2121 M Street, NW

Board of Zoning Adjustment
RENAISSANCE
CÉNTRO

**GOVERNMENT OF THE DISTRICT OF COLUMBIA
DEPARTMENT OF CONSUMER AND REGULATORY AFFAIRS
OFFICE OF THE ZONING ADMINISTRATOR**

From: Avitabile, David
Sent: Sunday, November 10, 2013 12:32 PM
To: 'Ndaw, Mamadou (DCRA)'
Cc: 'LeGrant, Matt (DCRA)'; Epting, John; 'Ilan Scharfstein'
Subject: 2121 M Street (B1310607) - Response to Zoning Review Comments
Attachments: RE: 2121 M Street -- Review of our discussion; 2121 M Street -- Review of our discussion; Determination Ltr re 2109 M St to Epting 12-6-2010.pdf; At-Grade Connections.pdf; Valet Parking Plan.pdf; Hyatt Place M Street Rooftop Structures .pdf; Hyatt Place M St Site Plan - loading.pdf

Valet Parking Plans

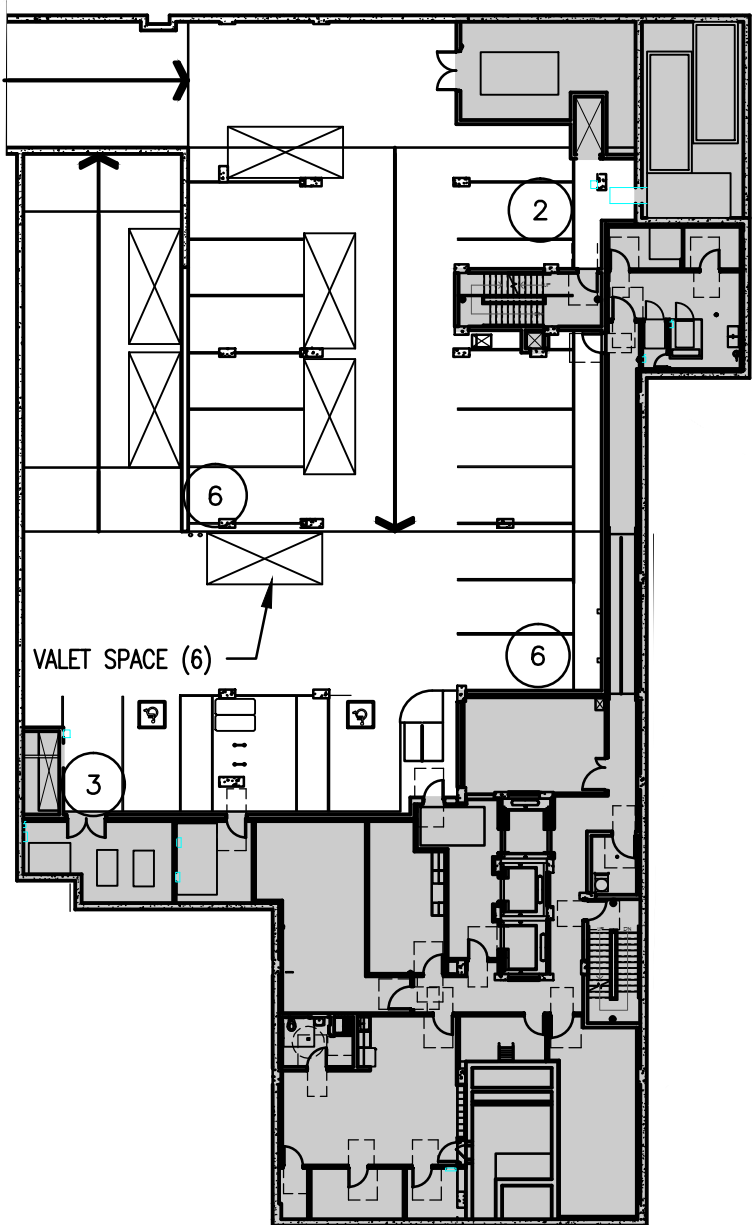
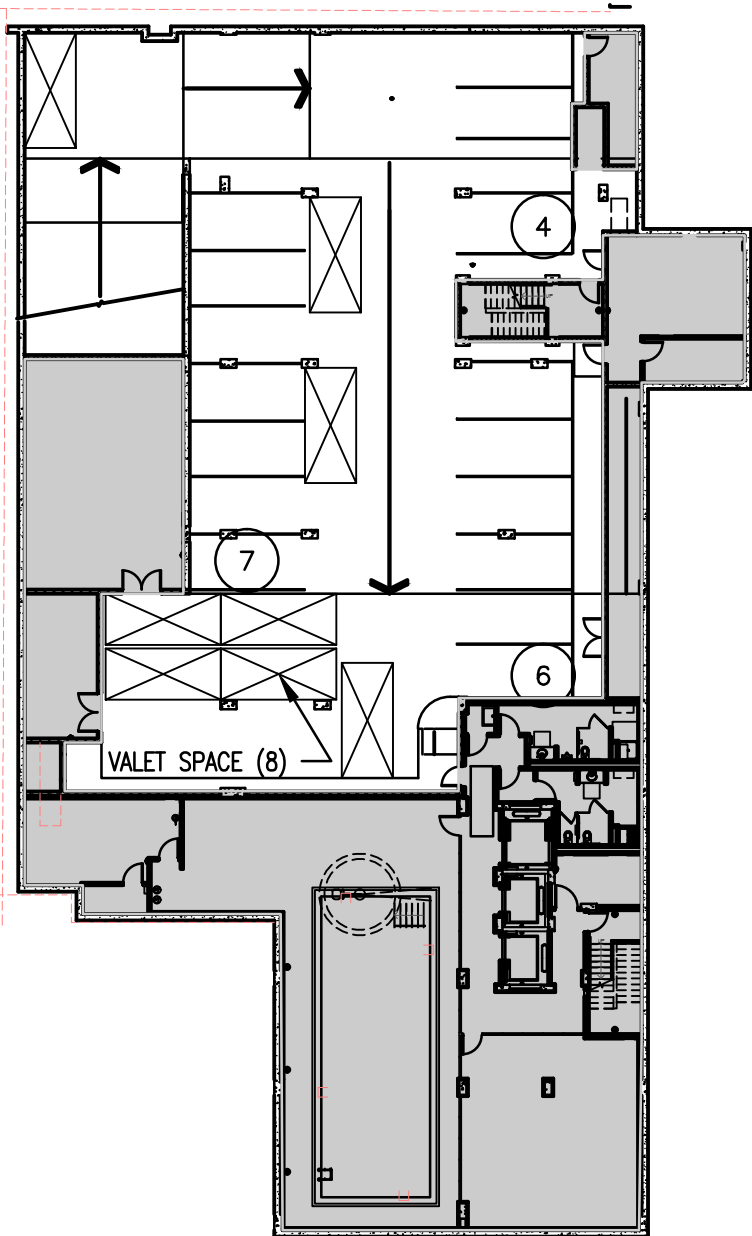
Section 2101.1: The building has 168 rooms and a 1,710 s.f. function room, for a total parking requirement of 48 spaces (1 per 4 rooms and 1 per 300 s.f. of the largest function room space). We are going to exercise our prerogative under Section 2115.9 to use valet parking to meet our parking requirement. With valet operations, we can provide all 48 spaces within our garage. See attached valet parking plan.

Section 2117.4: Good question. As is noted on the Lower level 1 plan of the Valet parking plan, our parking garage is accessed directly from 22nd Street via an unobstructed private drive that runs under the existing Washington Marriott to our garage. The ramp exists now; we just need to connect to it. We have provided a plan that shows the required loading spaces; the architects have also shown the location of the ramp.

M STREET TEST FIT
TYPICAL FLOOR (REVISED
11/26/10)

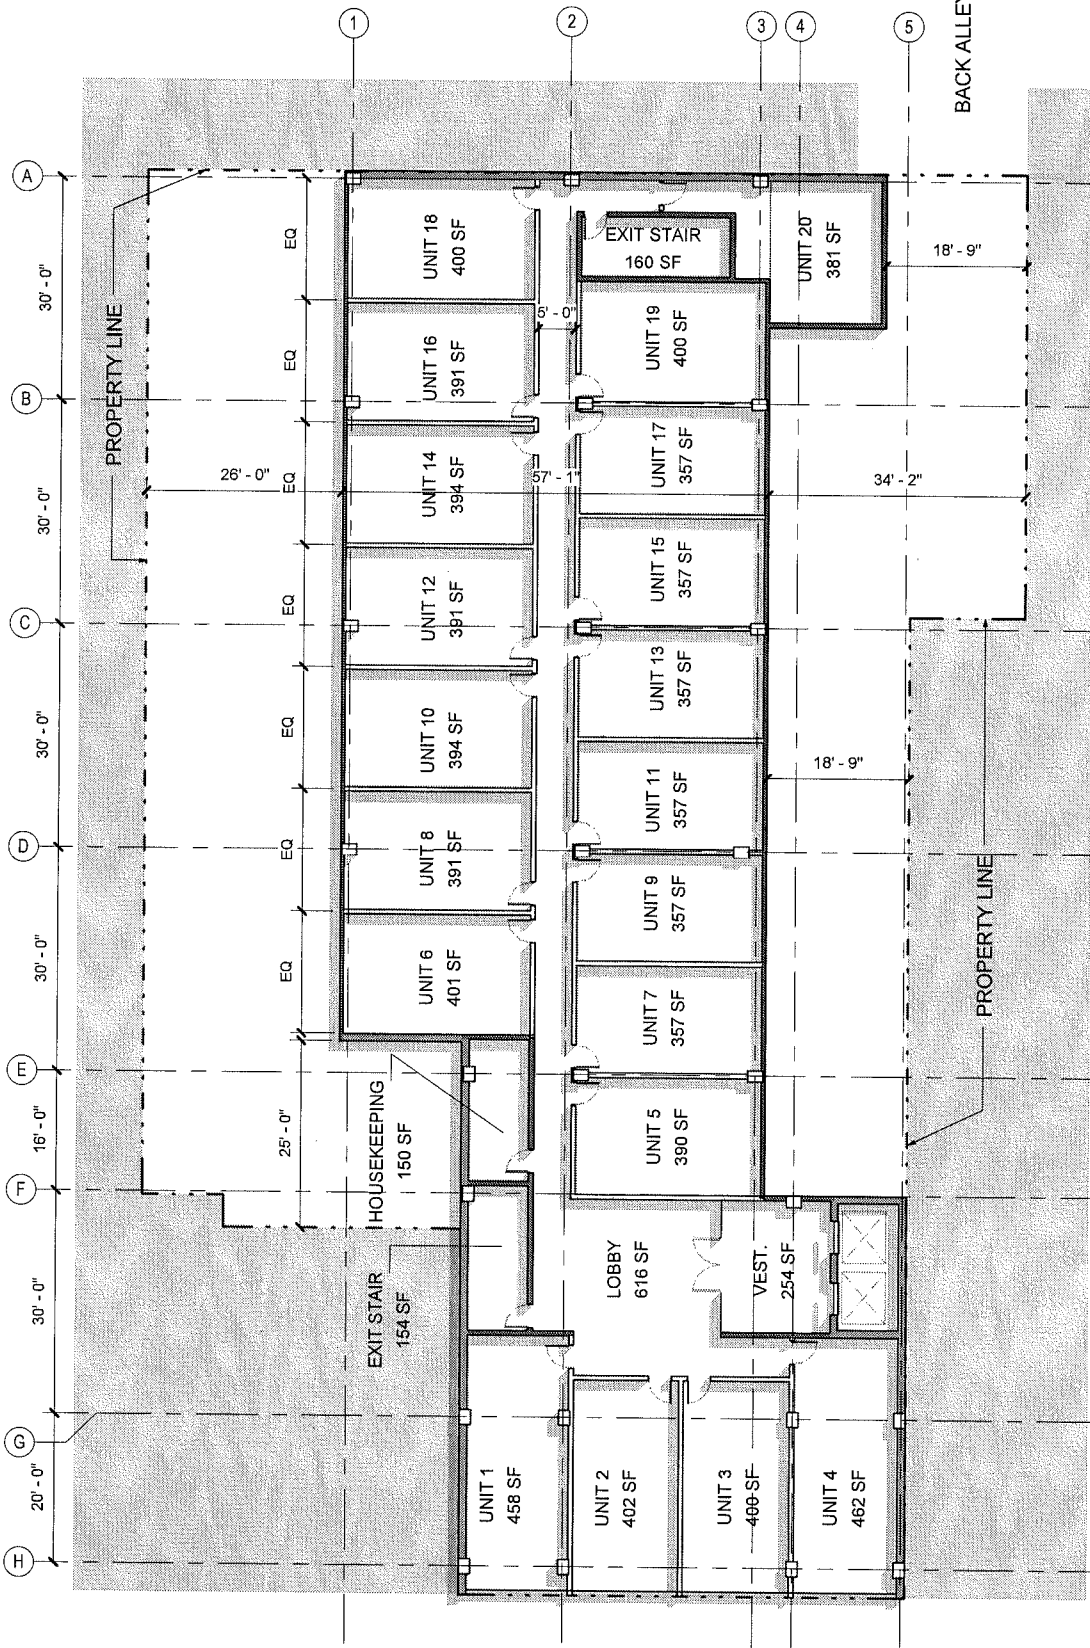
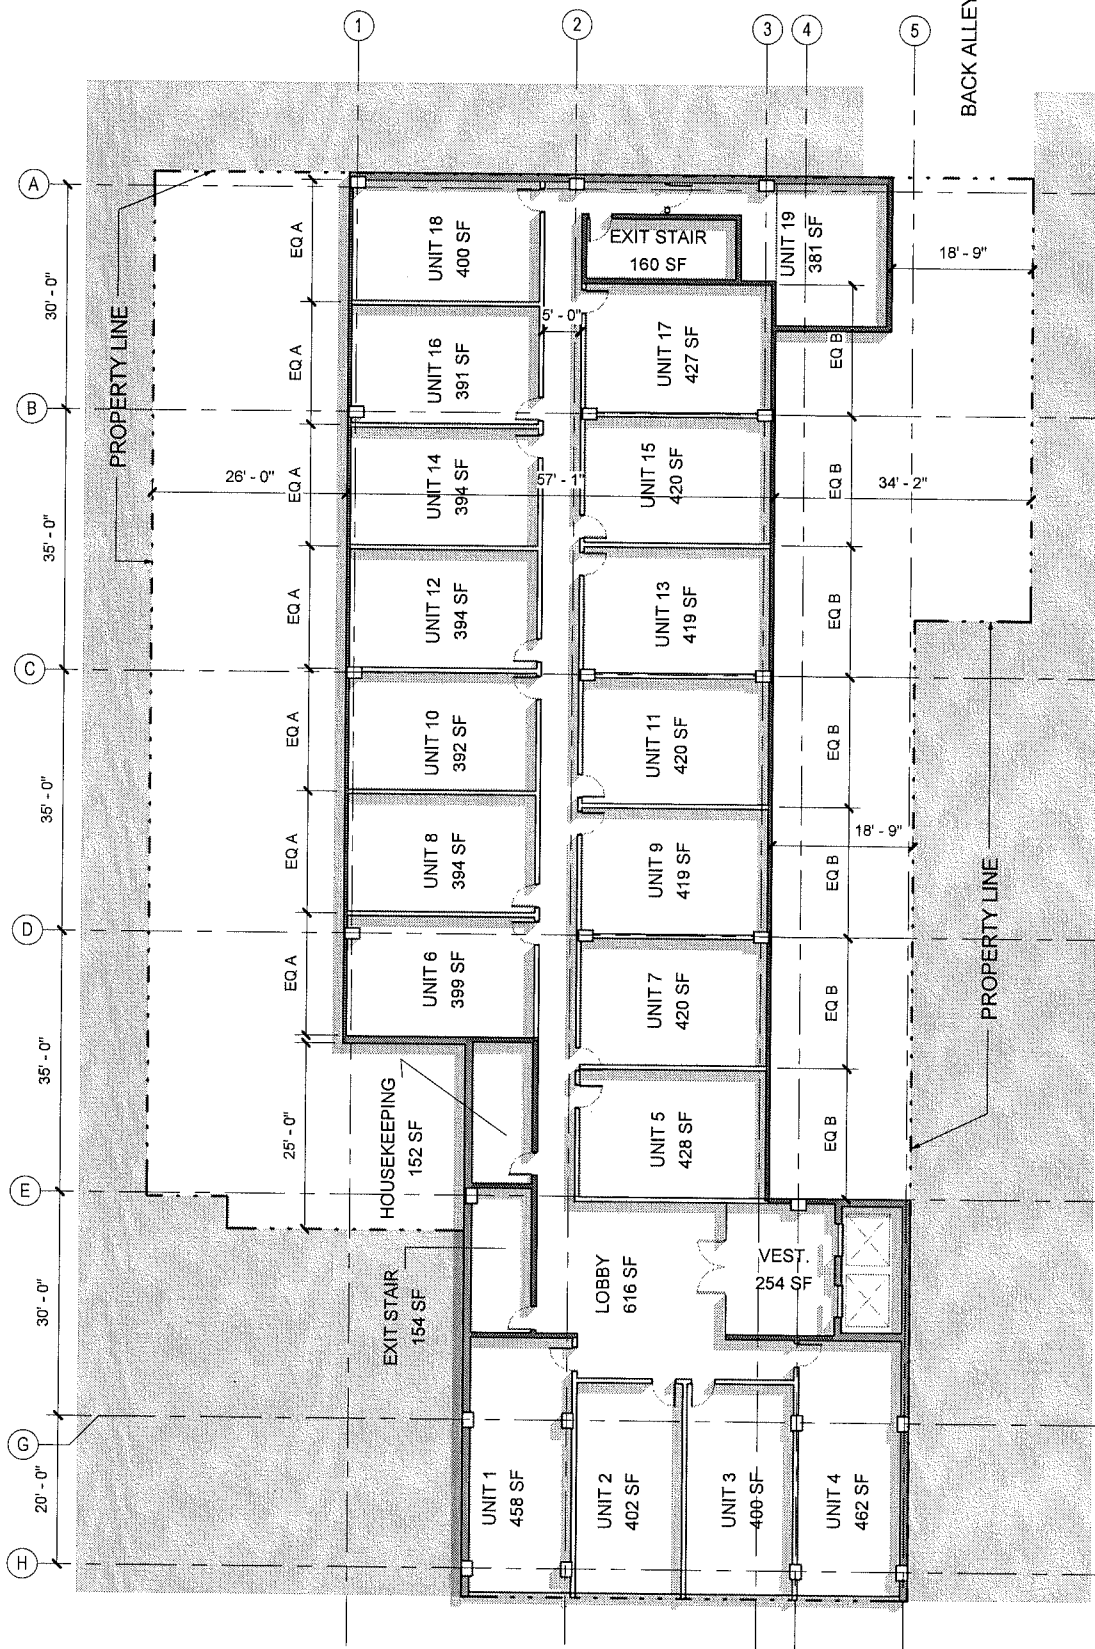
According to the 1978 Comp Sheet and attachments thereto, the open area on the Record Lot above the Property and the adjacent private alley were historically considered to be one open court.¹ As shown on the test fit drawings attached as Exhibit A, the proposed Project will narrow this open court but continue to maintain it as one continuous open space along the east side of the Record Lot.

As shown on the test fit drawings attached as Exhibit A, a second court will be created in the center of the Record Lot, to the west of the Project. This court is surrounded on all sides by the Project and other improvements on the Record Lot and, therefore, is a closed court, because it is surrounded on all sides by the exterior walls of the “building” (meaning, the single building for zoning purposes created on the Record Lot). Again, the required width and area of the court shall be based on the height of the court.

Accordingly, I conclude that this court will continue to meet the definition of “open court” under the Zoning Regulations. For purposes of calculating the required open court width, the court should be segmented into two separate pieces – one being the volume beginning at the ground level that roughly corresponds with the private alley, and the other being the volume that begins above the ground floor of the Project. Since the width of the latter volume is irregular, it may be calculated based on the diameter of the largest circle that may be inscribed in a horizontal plane within the court. The required width of this court shall be based on the height of the court.

1st FLOOR PLAN

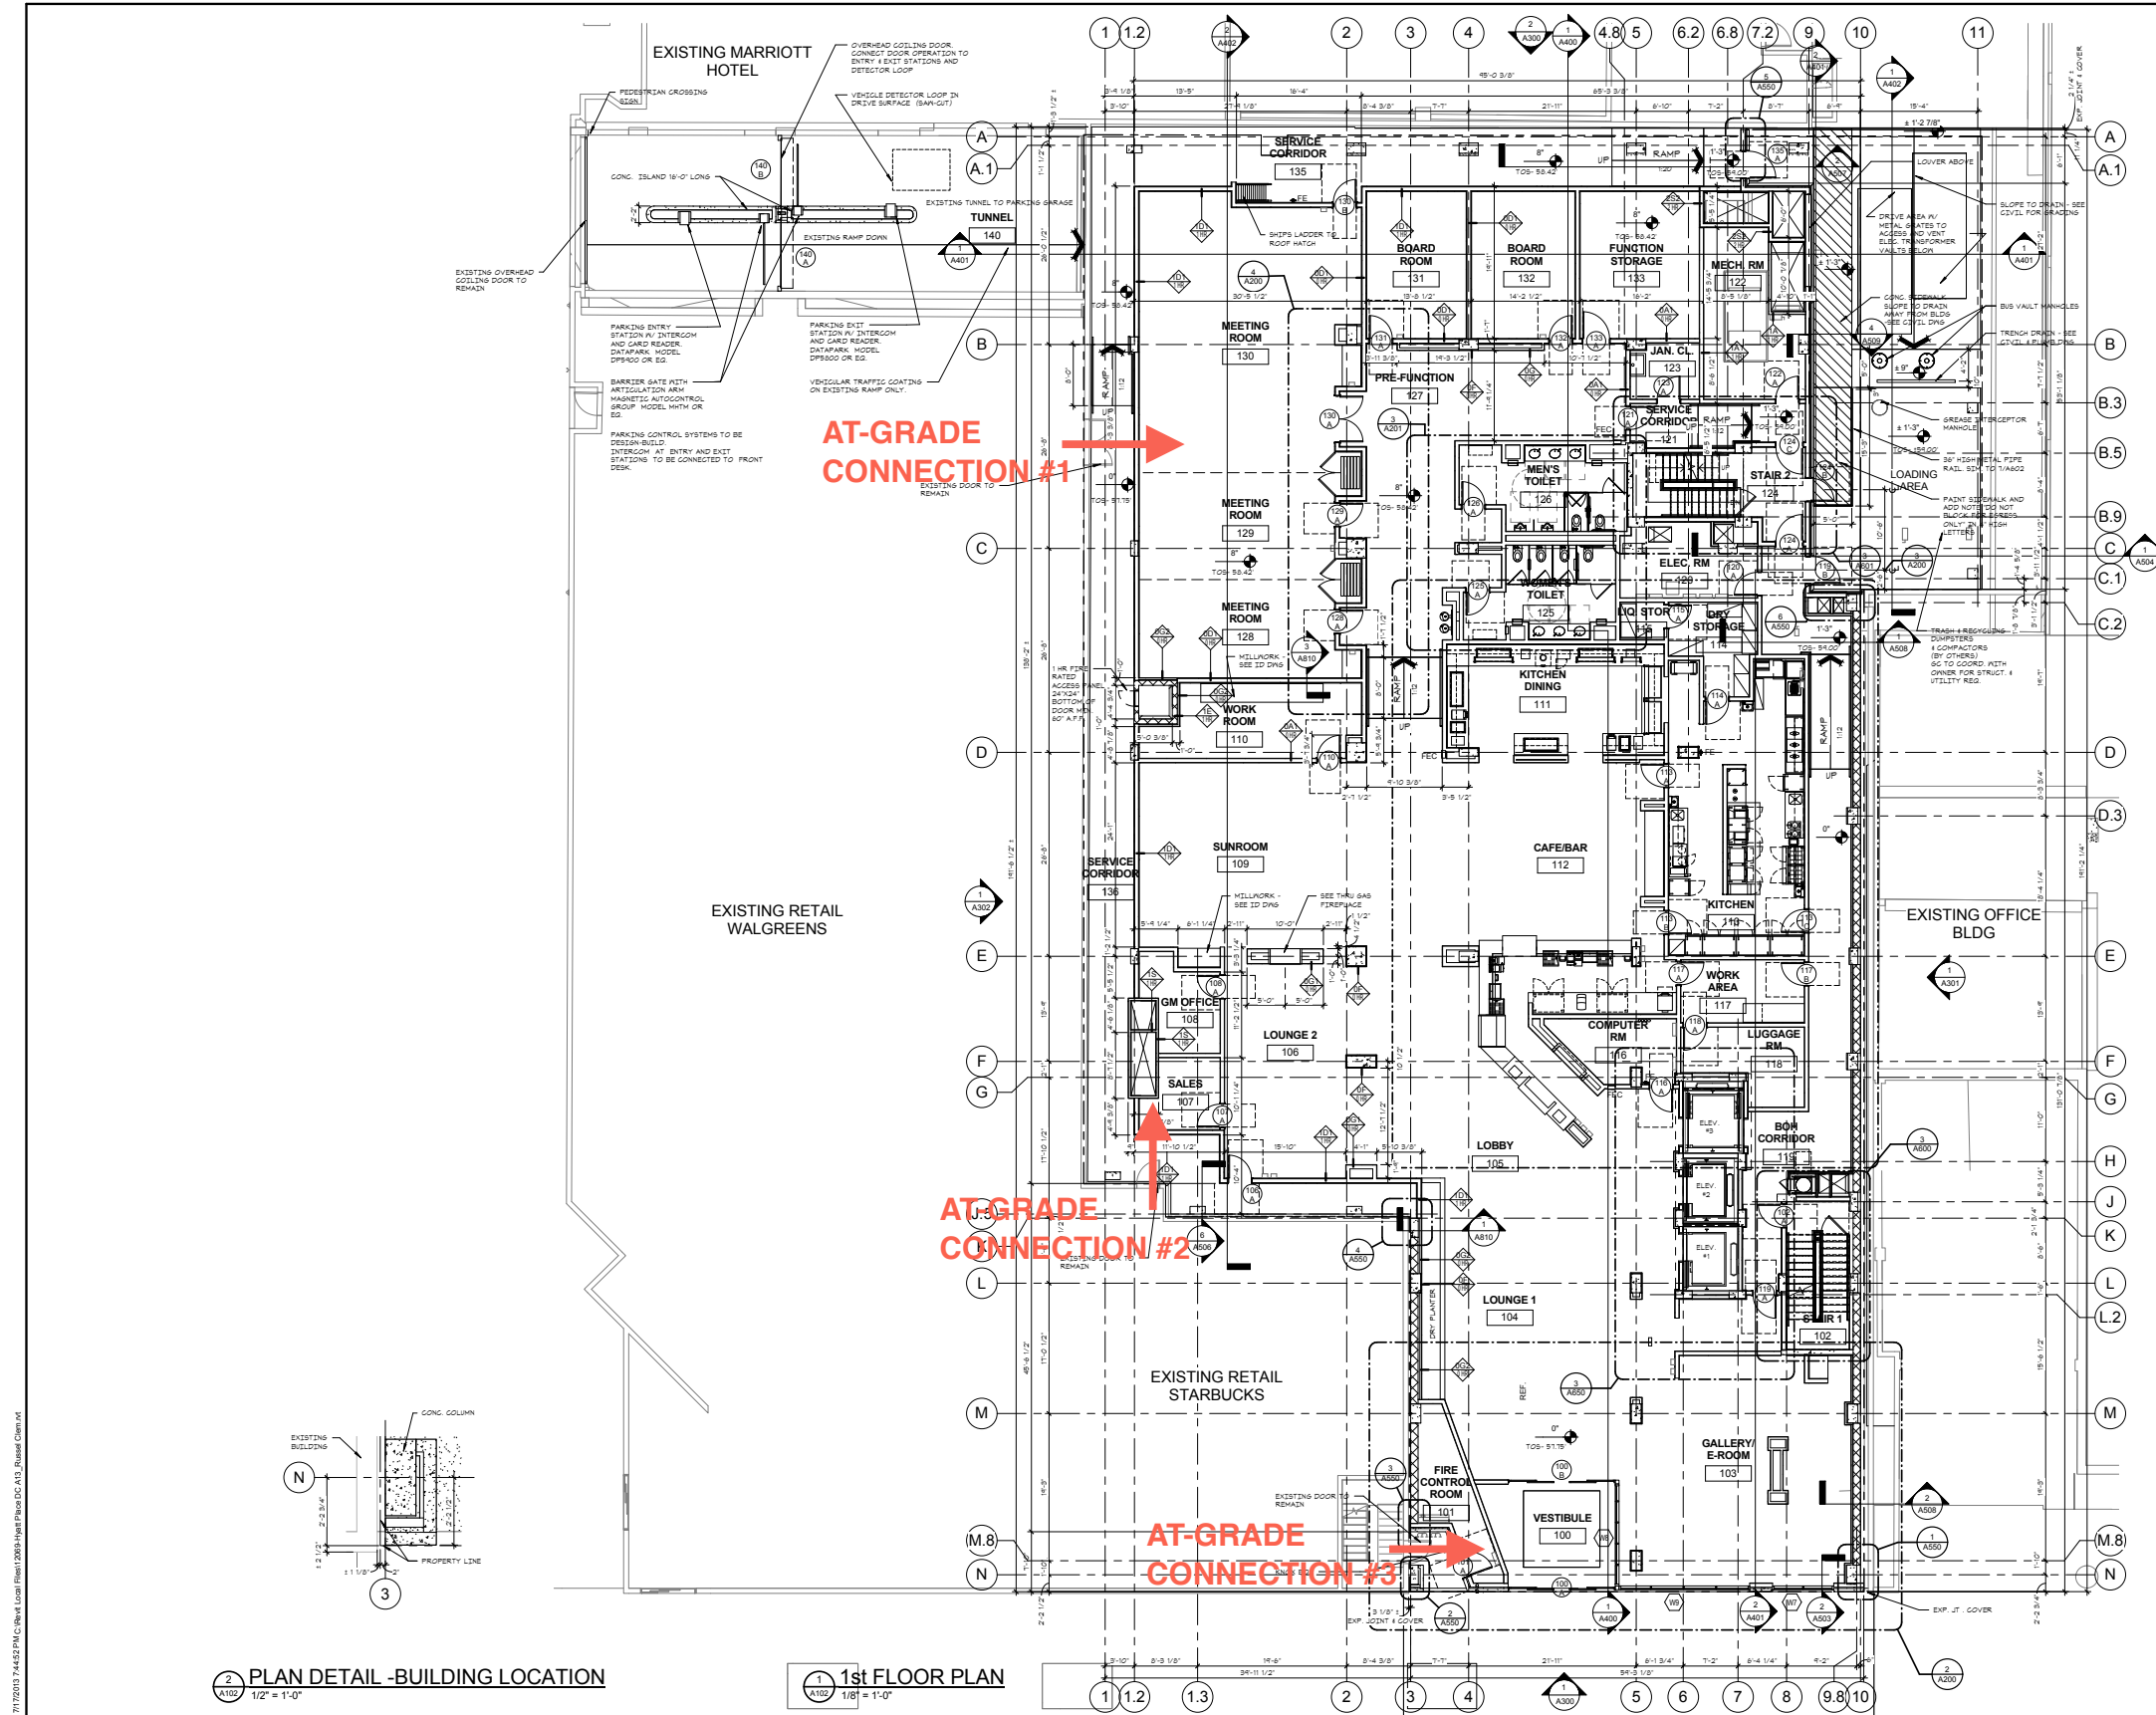
1. Please apply for a subdivision to convert the tax lot into a record lot. 2. Please explain what "addition to the existing Washington Marriott Hotel" means. Is the new hotel a separate entity from the Washington Marriott Hotel? If not please contact me by email before resubmitting the plans.

This was confirmed in our July 2013 meeting with Matt and is described in our August 2013 letter to Matt. Our property (Lot 880) is located on the same single record lot as the Washington Marriott and some ground floor retail establishments. Our Project will be connected to the other structures on the record lot through (a) the Marriott's hotel stair tower, which will exit into a vestibule within our building before discharging people out to M Street and (b) through doors at the rear of the retail spaces that provide access through and across a corridor on our parcel to the rear loading area and private alley. These connections are at street level and are therefore at or above the main floor of the

structures. Accordingly, Matt confirmed the structures will constitute one building for zoning purposes. For your convenience, I've marked up the ground floor plan to call out the at-grade connections described above.
